Sunnyside Coal Mine Modification 4

Highwall Drain

State Significant Development Modification Assessment
(MP06_0308-Mod-4)

June 2022

Figure 2 | Modified Final Landform (Source: Sunnyside MOD 4 Modification Report, Whitehaven)

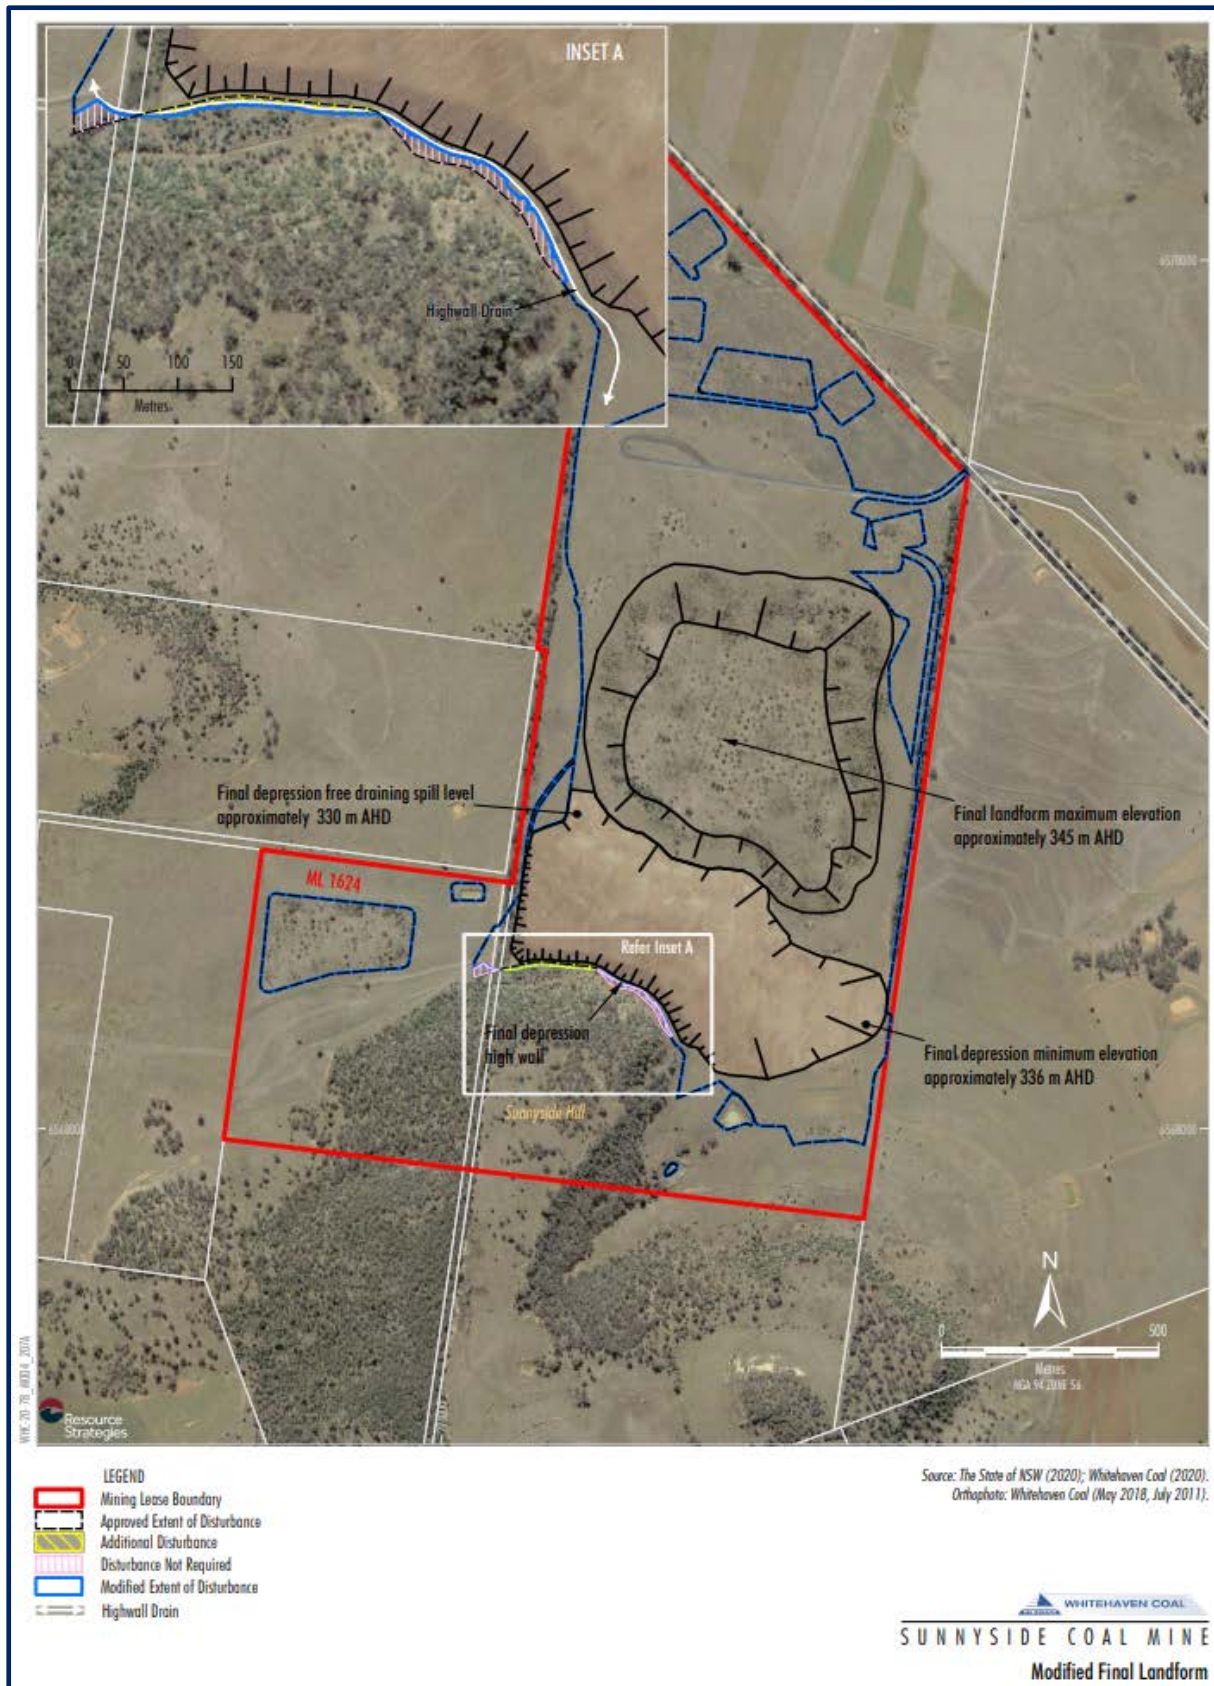
Whitehaven is seeking a modification to its approval to construct an approximately 660 metre (m) long diversion drain along the top of the highwall to protect the highwall and rehabilitated areas from erosion and ensure the highwall remains stable after mine closure.

The drain footprint is shown in **Figure 2**. The drain would have an average width of 5m and would be revegetated, with rock protection used in erodible areas, as required.

The **Resources Regulator** did not require any further information. Additionally, it was noted that the design in the modification report is conceptual only, and should the modification be approved it will be the requirement of the title holder under the *Mining Act 1992* to develop a detailed design of the drain to address potential risks that may compromise the overall intent of the modification.

Gunnedah Shire Council (Council) recommended that the extent of the change should be clearly marked during works and that no additional vegetation is removed beyond the proposed change.
